From: [Puco ContactOPSB](#)
To: [Puco Docketing](#)
Subject: public comment and attachments for 20-1679
Date: Wednesday, April 7, 2021 3:51:19 PM
Attachments: [DCA Audubon letter 20210126.pdf](#)
[Pleasant Prairie Darby Creek Stakeholder Response 3.19.21 Reprint.pdf](#)
[20210407Comments on Pleasant Prairie Solar wetlands hydrology native vegetation.docx](#)

Subject: DCA/CA response on Pleasant Prairie Solar: Native Vegetation, Wetlands, Hydrology and Bird Impacts

Response to Comments on Pleasant Prairie Solar: Native Vegetation, Wetlands, Hydrology and Bird Impacts
From Darby Creek Association and Columbus Audubon

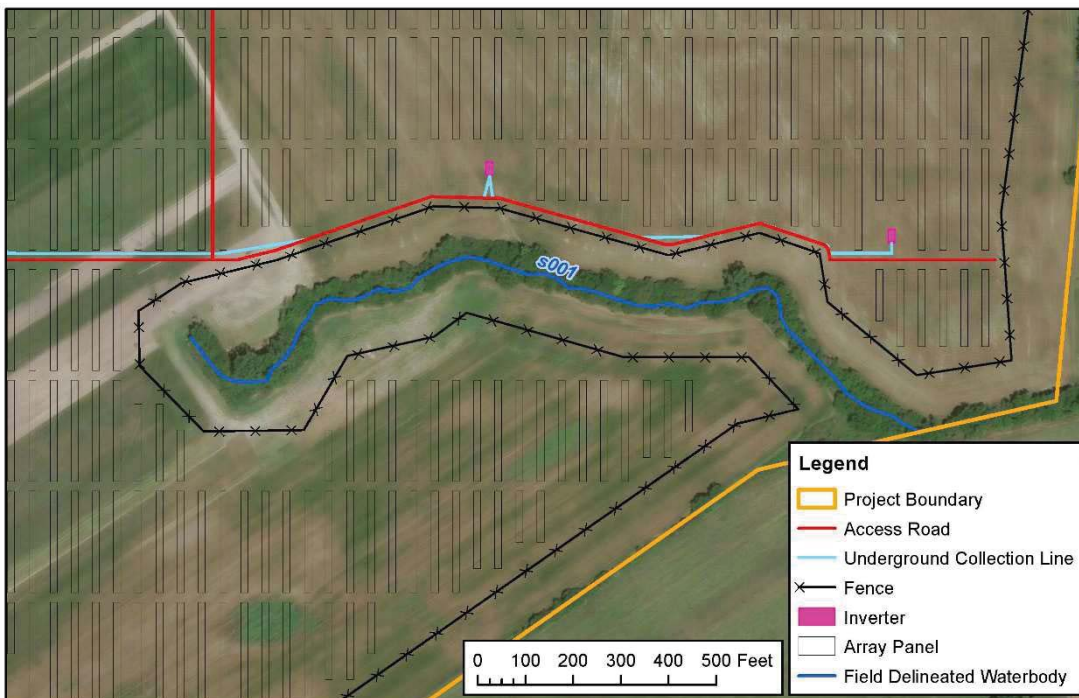
- 1) Wetlands: The facility should ensure adequate protection of wetlands, starting with a complete and proper Inventory and delineation of all wetlands, including temporary wetlands (Category I), and adequately protective buffers, adequate protection of wetland hydrology, preservation and enhancement of wetland wildlife, and connection to conservation land. We understand that as part of Clean Water Act obligations the facility will need to produce wetland identification, delineations and wetland scoring for the Army Corps of Engineers and Ohio EPA. We expect to have other protection points to follow. We expect that wetland impacts will be avoided to the greatest extent practicable, and that significant wetland enhancement might be possible, especially given the proximity to Battelle-Darby Metro Park.

As part of our site evaluation, the Project team conducted a detailed survey of surface waters (wetland and waterbody delineations) within the Project Area in fall of 2020. This Report was provided as part of our Application to OPSB, see Exhibit C - part 5 of 25.

This report provides details on delineated features including their scoring on the ORAM or HHEI/QHEI assessment forms. A total of 15 wetlands and one pond were delineated during field surveys, for a total of 8.15 acres of wetlands within the Project Area. Eleven of these wetlands were categorized as emergent, three were categorized as forested, and one was categorized as shrub-scrub. One wetland (W-002) was categorized as potentially jurisdictional and scored as lower quality wetlands on the ORAM. No wetland crossings are proposed, and we anticipate no impacts to wetlands from the construction or operation of the Project based on our current design.
